# CITY OF ALBUQUERQUE

RE: **Lot 15 Block 5 Volcano Cliffs Unit 18 SAD 228**  
**7808 Compass Dr. NW**  
**Grading and Drainage Plan**  
**Engineers Stamp Date Rev. 12/16/2022 (D10D003G36)**

## DRAINAGE AND TRANSPORTATION INFORMATION SHEET (REV 6/2018)

7808 COMPASS DR., N.W.  
GRADING PLAN

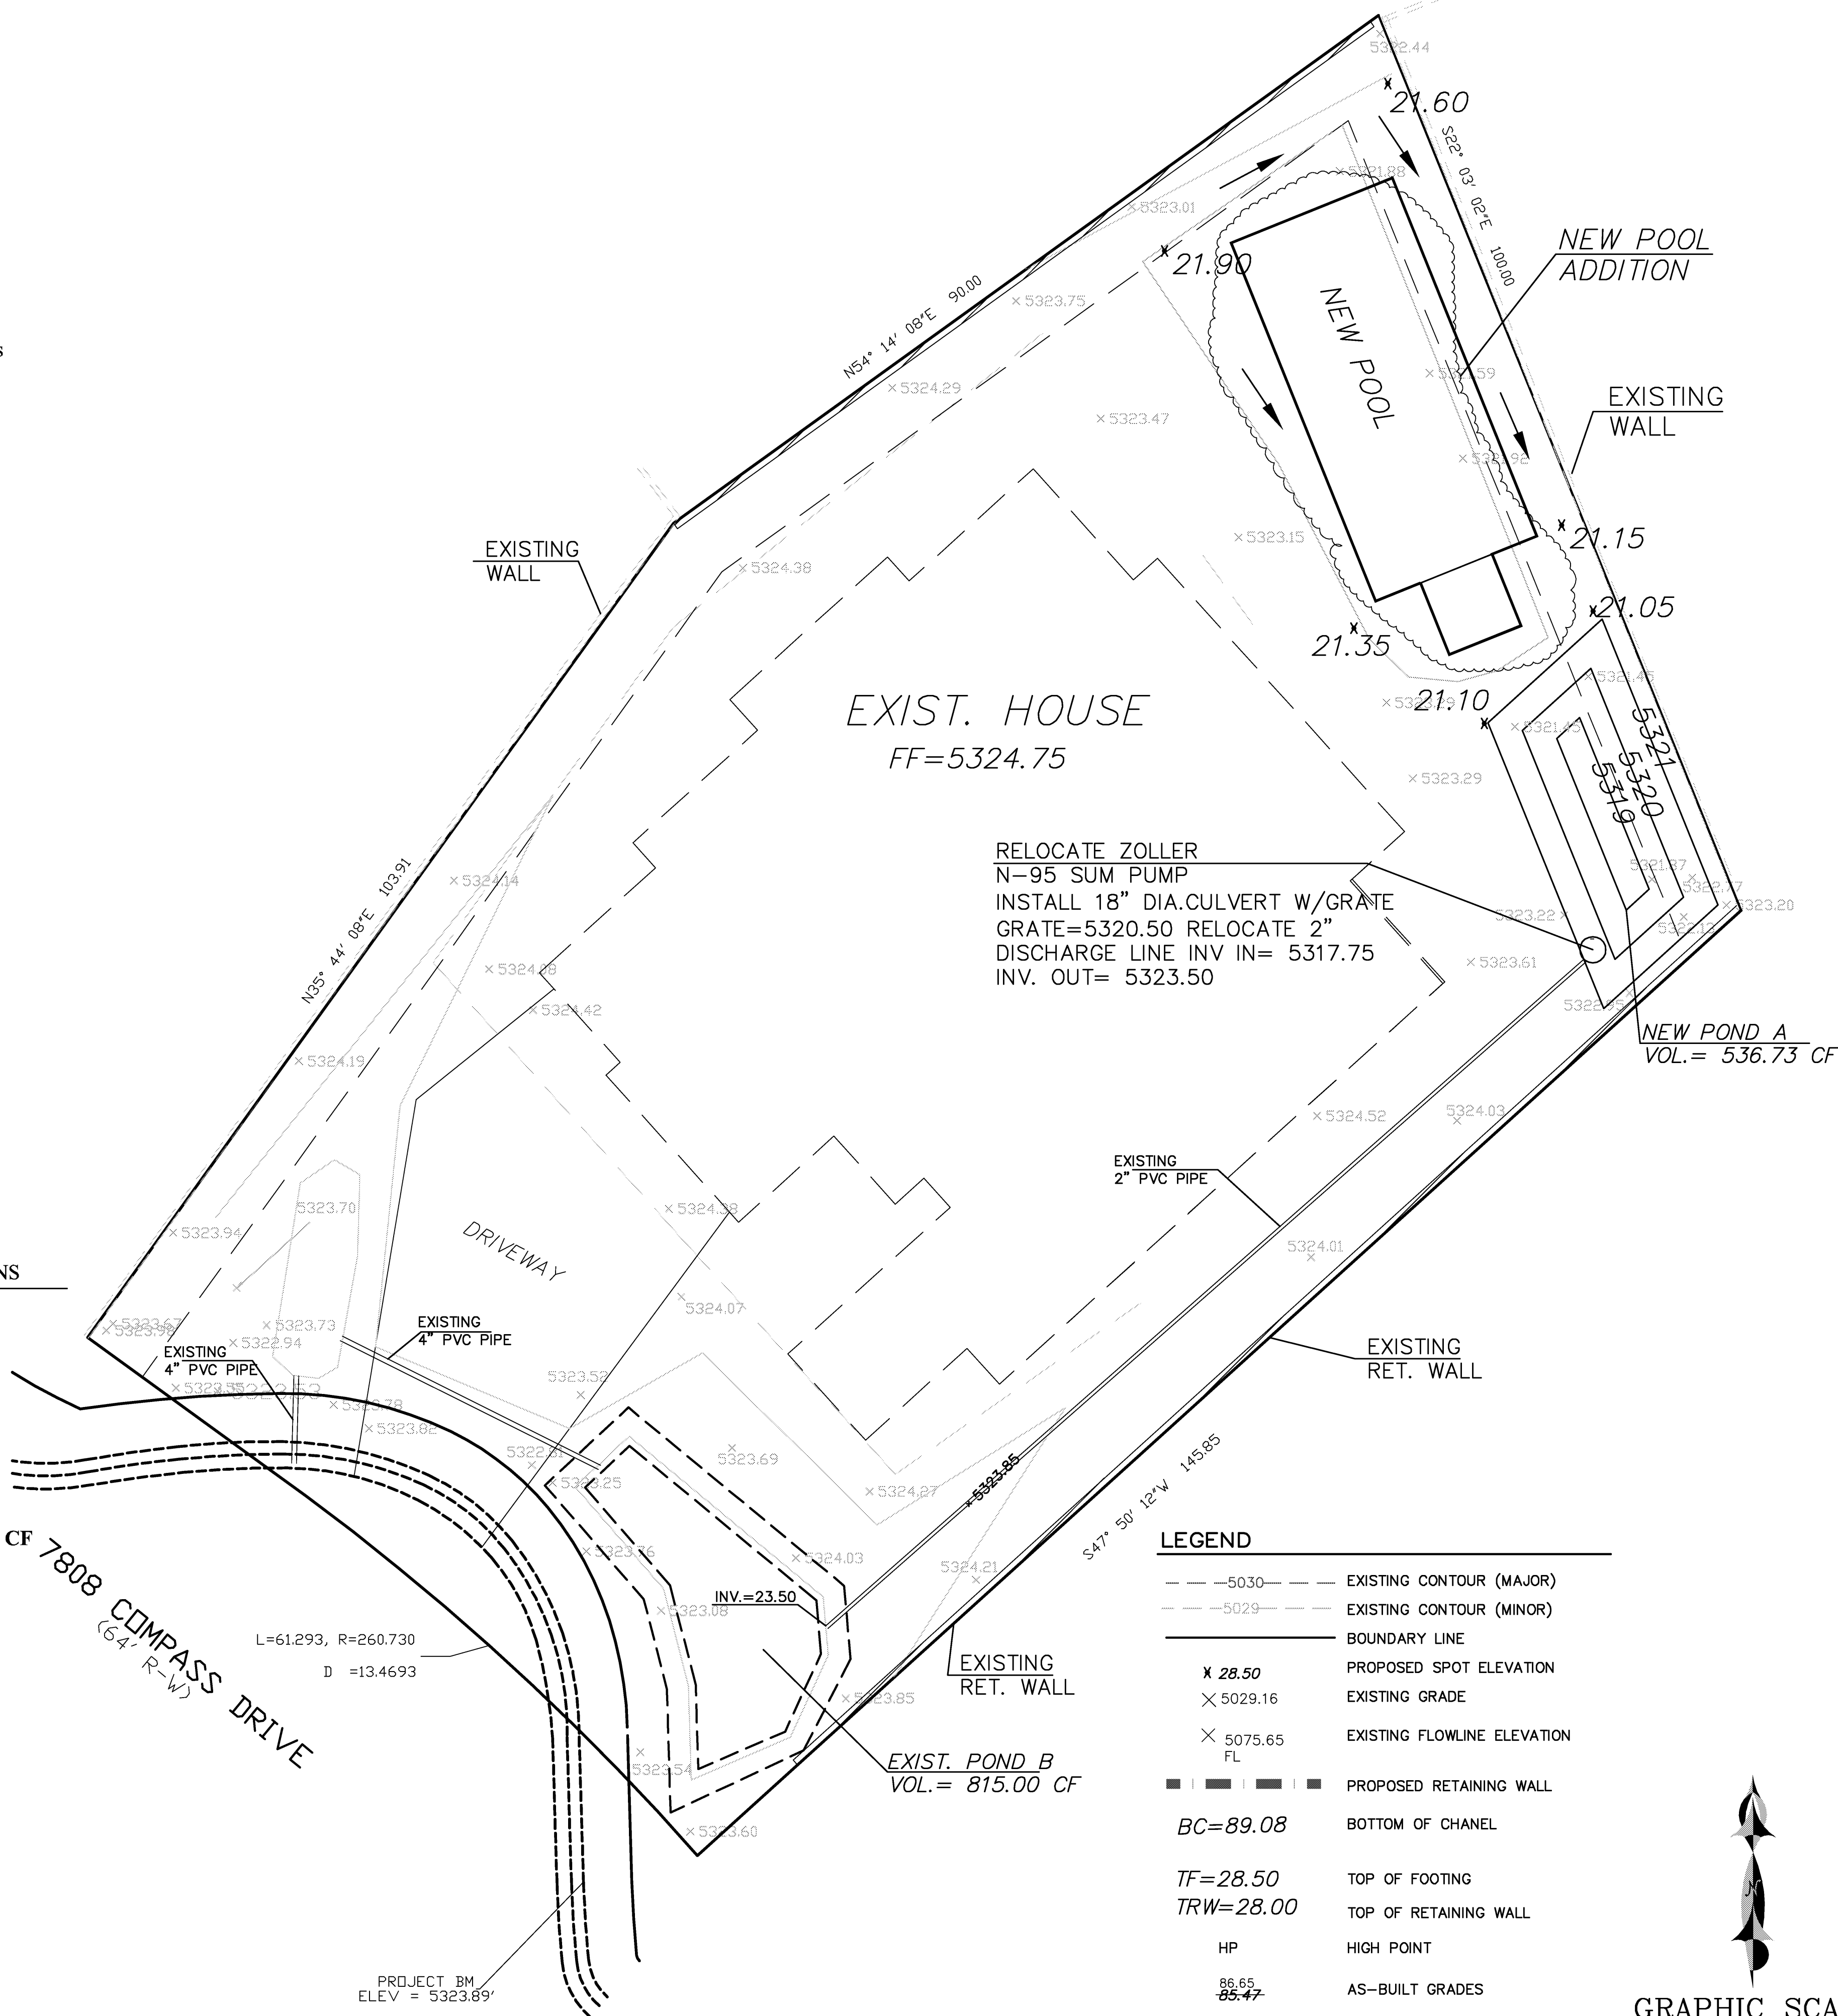
Based upon the information provided in your submittal received 12/26/2022, this plan is approved for revised grading plan.

Hydrology inspection is required before final CO is granted.
